To: Director – Infrastructure Projects Department of Planning and Environment Application number – SSI 13_6136 Major Project Assessment GPO Box 39 Sydney NSW 2001.	From: [Redacted] m
Ref: S20140901a Total 2 pages	Date: 1 st Sept 2014
Subject : 1. Tunnel Truck path in NorthConnex Southern Interchange 2. Air Quality Ventilation Outlet at Southern Interchange Attached tw0 submissions – Ref S20140828a and S20140805a

Att: Director –Infrastructure Projects
Department of Planning and Environment
Application number –SSI 13_6136
Major Projects Assessment
GPO Box 39 Sydney NSW 2001.

Figure.1 Impact of air quality affected by wind air flow within 1 KM resident area.

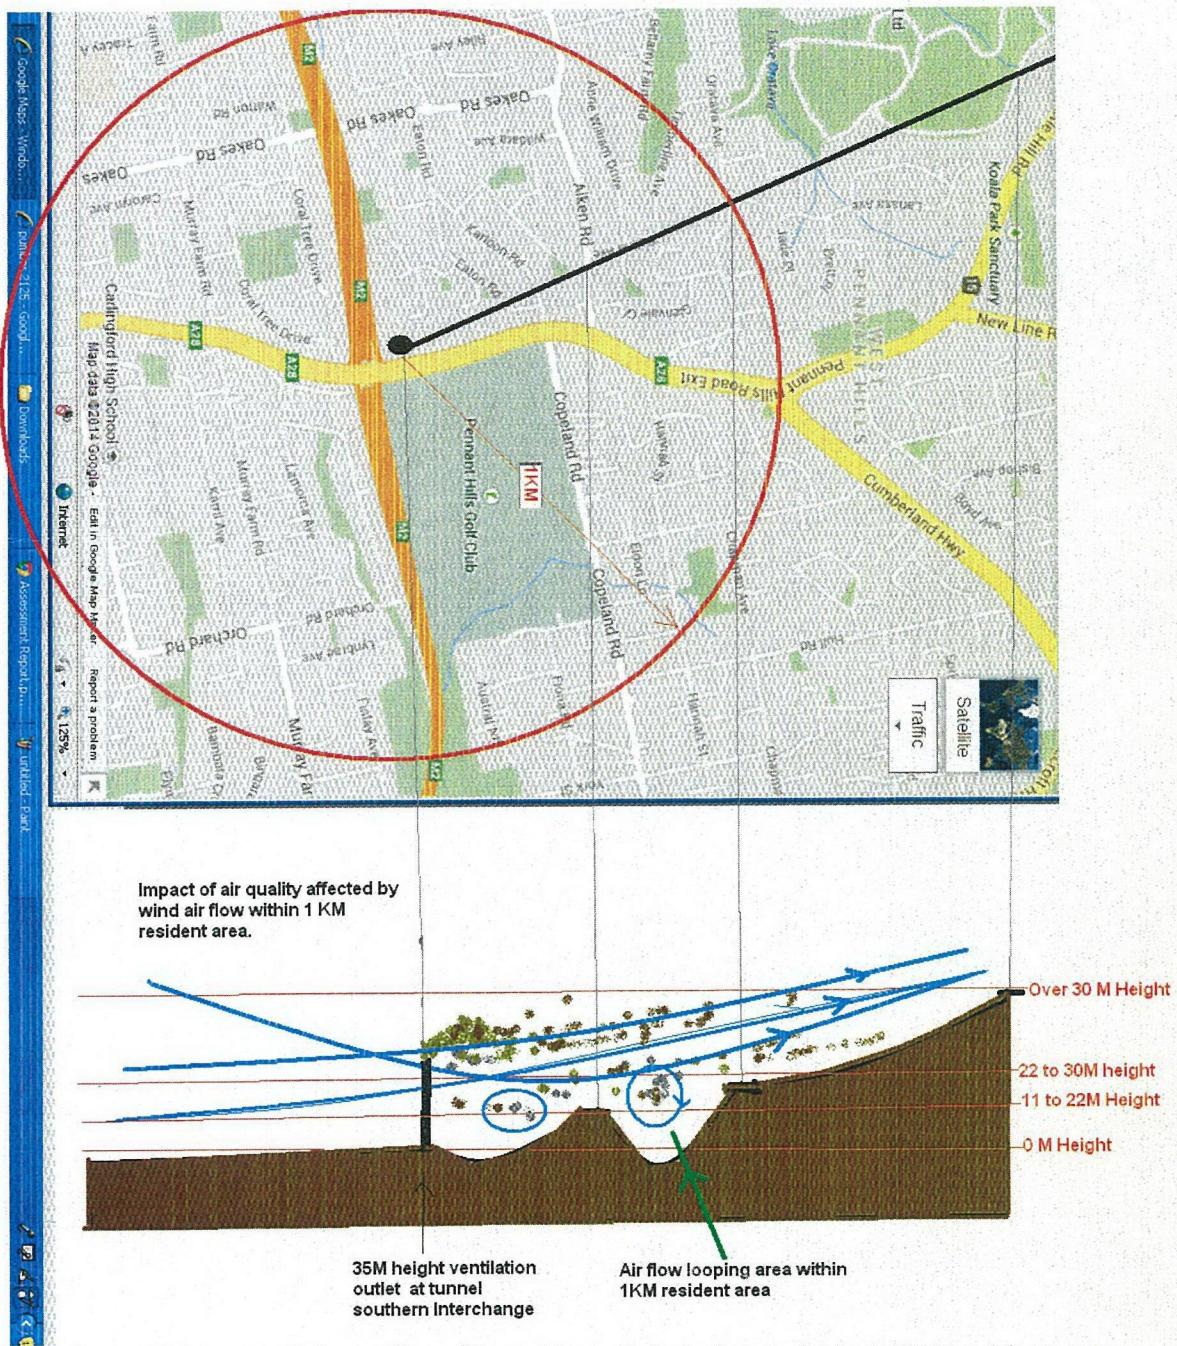
The Hill terrain at the NorthConnex southern interchange is complicate. Within 1 KM surrounding area (see Figure1), relative to the (0m) height at southern ventilation outlet, it has 22m height at 1 Aiken road, more than 30m height at Thompsons corner and -20m height in Dehlson ave (West pennant hill Val).

Can the high concentrated pollutant be distributed out into the air within this 1KM area and maintaining good (2014) Air Quality standard? The answer is not clear yet till the real operation (but it is too late). As such, two detail models proposed in the attached request for further detail simulation the impact of real environment within 1KM surrounding area at southern interchange. Also, please, reserve the sufficient space to build the air treatment at the (southern interchange) ventilation outlets planning for the possible solution to improve the air quality if it failed to maintain the (2014) Air Quality Standard within 2KM surrounding area.

Figure 1 Air Quality from RMS222_NorthConnex_Factsheet_DetailedAirQuality_Southern.pdf

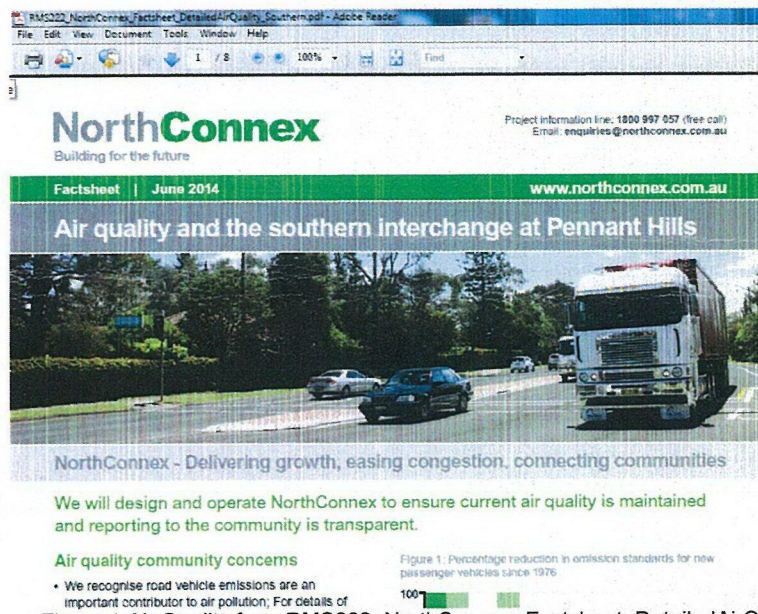
Figure 1 is the Fact sheet (June 2014) Air Quality proposed solution by NorthConnex for Southern Interchange. Dual (one upward and one downward/reversed) Air flow tunnels (9.2 KM) will be built from southern interchanges (144M Aust Height Datum) to northern interchange (180M Aus Height Datum). An estimated 4,000vehicles/hr will pass through the tunnel. High concentrated pollutant (bad air quality) generated by In-tunnel vehicles and will be drawn away by moving traffic and then extraction through a (30~35) M height ventilation outlet at both entries. Filtration technology (M5 East Tunnel filtration plant) will NOT be used.

This submission split into five parts in order to identify how the high air quality (2014) standard can be maintain/monitor/control within 2 KM surrounding resident area when the high concentrated pollutant emitted from both (35M height) ventilation outlets for NorthConnex tunnel operation in 2019:

Two simple (models) solutions proposes for the real environment simulation how the aerodynamics Design to improve the (real) Air flow within 2KM surrounding resident area from the (35M height) tunnel ventilation outlets:-

E1. Real simulation model 1. Hire a (long range arm) truck to carry a smoke generator and elevates it up to 35M height at the proposed tunnel ventilation outlet. It simulates the wasted gas emitted from a chimney at the (fire) power station. If wind air flow (all direction) push smoke upward to the sky. The solution of tunnel ventilation outlet is accepted. If Not, it need to design the tunnel aero-dynamics to enable the air flow upward to the sky without affect 2km surrounding resident area or alternative air treatment should be improved at the ventilation outlets.

E2. 3D simulation model 2. Use a 3D printer to produce 2km surrounding resident area model. Air flow is simulated in difference direction point to the (smoke) ventilation outlet point. Improve/modify the tunnel ventilation outlet aero-dynamics design to enable the smoke air flow upward to the sky without affect 2km surrounding resident area.

Figure 1. NorthConnex Southern Interchange

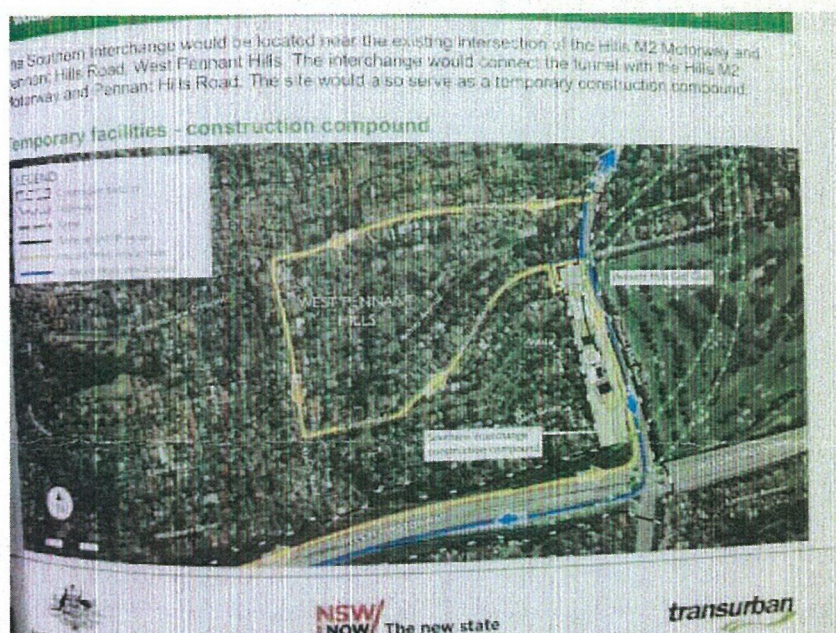
A. Comments to (Figure 1) NorthConnex Proposal below:

A1. The Impacts/Risks to the hill's resident area are:

1. **Impact of further overloading the road Traffic** – existing traffic is being overloading in the said suburban streets during the peak/busy hours. How could the said suburban streets further overloading the additional (1480/day) heavy tunnel trucks and (330/day) small cars.
2. **Impact of (high dB) truck Noise/Min** – High dB noise (each min) produced by each tunnel heavy truck pass through said suburban streets. And high impulses of truck's break stop noise.
3. **Impact of Air pollution created by the truck/min to the resident.**
4. **Impact of Soil dust** affects all resident for each heavy tunnel truck passing the said suburban streets.
5. NorthConnex requires paying construction cost to enlarge the turning space for the tunnel trucks driving a (90 deg) angle turning from Oakes road into Eaton road.

6. **Maintenance cost.** Road (suburban streets) damaged required high Maintenance cost (to be paid by NorthConnex)
7. **Impact of vehicles type change,** Council classified the type of heavy truck (more than 3 tones) is restricted to pass through the said suburban streets. The purpose is reduced noise to the resident.
8. **Waste of truck oil consumption.** Each day (1480) heavy Trucks drive on the proposed suburban streets. How much cost will be waste in the truck Oil consumption if it can be avoid.
9. **Waste of truck operation cost.** Each day, (1480) heavy trucks run through the suburban streets. How much cost/time will be spend on the Truck driver to delivery soil on the road. The operation cost can be reduced if it can be avoid.
- 10 more will be coming...etc.

Figure 2. Road Inspection at Junction of Copeland/Eaton/Pennant Hill Roads

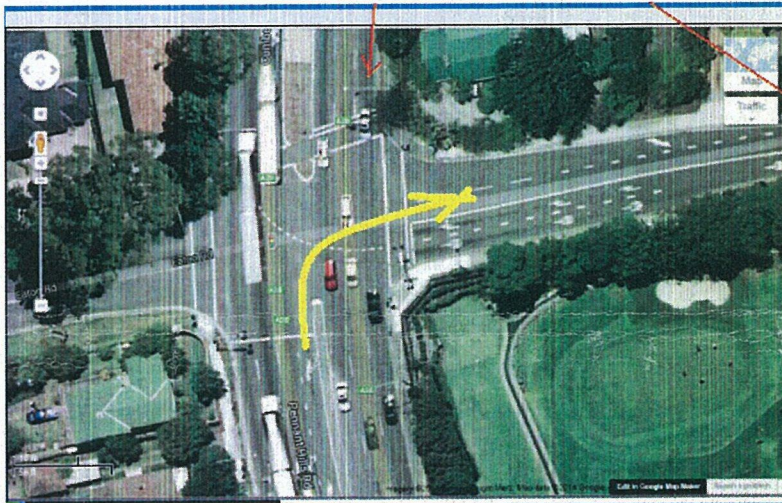
- B1. Vehicles North Bound (Parramatta -> Hornsby) – 1min 10sec
- B2. Vehicles South Bound (Hornsby->Parramatta) – 1 min
- B3. Vehicles allow left turn from pennant hill road in to Copeland road (15sec).
- B4. Vehicles from Eaton road to Copeland road or left/right turn to pennant hill road (10 ~15sec).
- B5. Vehicles from Eaton road to Copeland road to Eaton road or left turn to pennant hill road. (10 ~15sec).
